21/00652/FUL

ERECTION OF A 4.0 M HIGH TIMBER FENCE TO PART OF WESTERN BOUNDARY FRONTING MOORGATE ROAD AND SOUTHERN SIDE BOUNDARY

Venus 217, Delphi Trading Estate, Moorgate Road, Southdene, Kirkby

Figure 2.

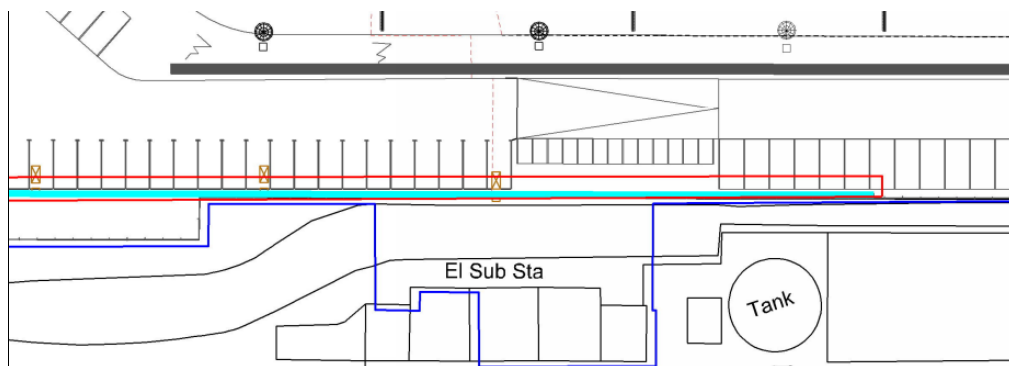
- Nevertheless, there is uncertainty, particularly in the area where there are trees in the location identified below (Fig. 2):

Figure 3.

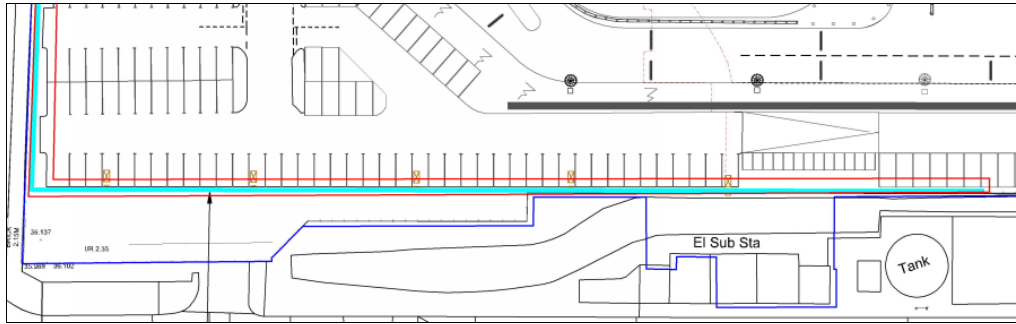
- From the information submitted it would appear that the erection of the fencing would prevent access for the maintenance of land between the red and the blue line (Fig. 3 and 4). Please clarify.

Figure 5.

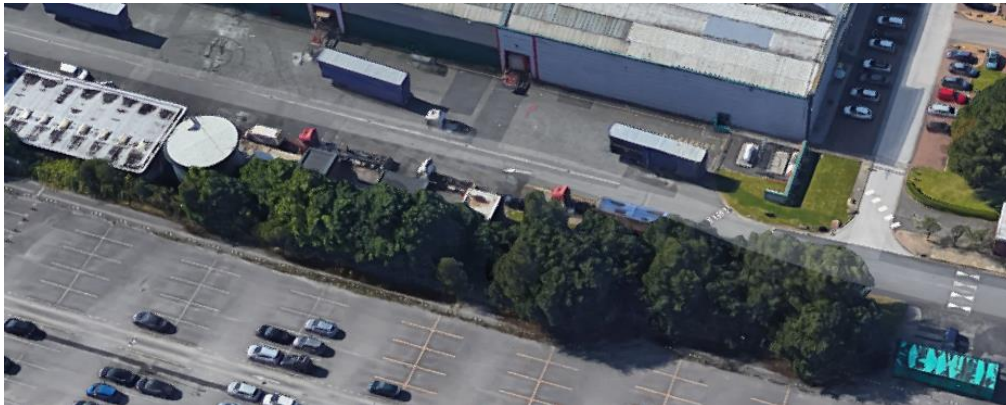
- Initial view of Google Maps (Fig. 5) appears to indicate that there are trees along the southern boundary.

- The trees have previously been identified in an Arboricultural Implications Assessment (Group 7) accompanying application 16/00400/FUL (condition 4 refers).
- Consultation has been carried out with the Council's Arboricultural Officer in relation to the need for tree reports.
- In response the Council's Arboricultural Officer has indicated that before he could answer whether reports are required, he would need to know

which side of the existing fence the proposed fence would be located. If it's going between the trees and the existing paladin fence then yes, a report would be required. If it's on the other side then we would be okay, looking at the fence specs and given it is just post being put in with no significant impact on the trees.
